# ADDENDUM COVER SHEET Addendum No. 1

Heritage Park Playground
Philadelphia Redevelopment Authority

Issue Date: May 25, 2023

**Reference:** Heritage Park Playground Bid Questions

(Question 3, Figure 1: Red line shows location of proposed guardrail.)

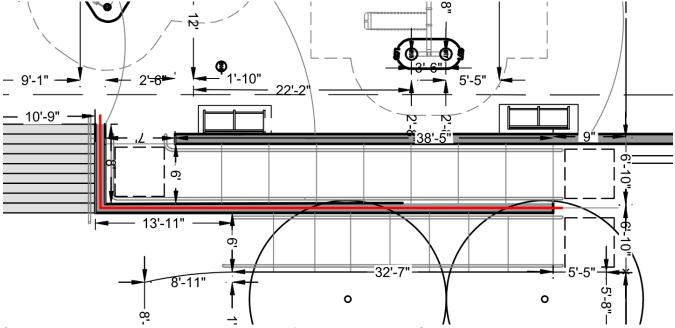
3. Plan L-4.1 shows the handrail at the upper section of the ramp to be in the ramp on each side. Detail 4/L8.2 shows the handrail to be on the center wall, please confirm the rail layout.

The elevation change between the upper and lower ramp runs requires a guardrail. The guardrail shall be provided with a side mounted handrail on the cheek wall dividing the two ramp runs, with the handrail facing the upper ramp run. Detail 4/L8.2, not plan L4.1, shows the correct condition. Plans will be revised to reflect the combination handrail/guardrail mounting location, which is to be centered on the "L" ramp cheek wall. The combination handrail/guardrail will be located in the "L" portion of the wall dividing the upper ramp from the lower ramp and adjacent stairs. The railings on the opposite side of the upper ramp and both on the lower ramp will be a handrail-only condition, which is the typical railing condition on the site. Detail 7/L2.1 (on sheet L8.2) reflects the combination handrail/guardrail style to be installed on the "L" ramp cheek wall. The guardrail shall be a minimum of 42" high from the paved surface and meet the loading/overturning requirements of the Building Code. The guardrail shall have vertical pickets with openings no greater than 4".
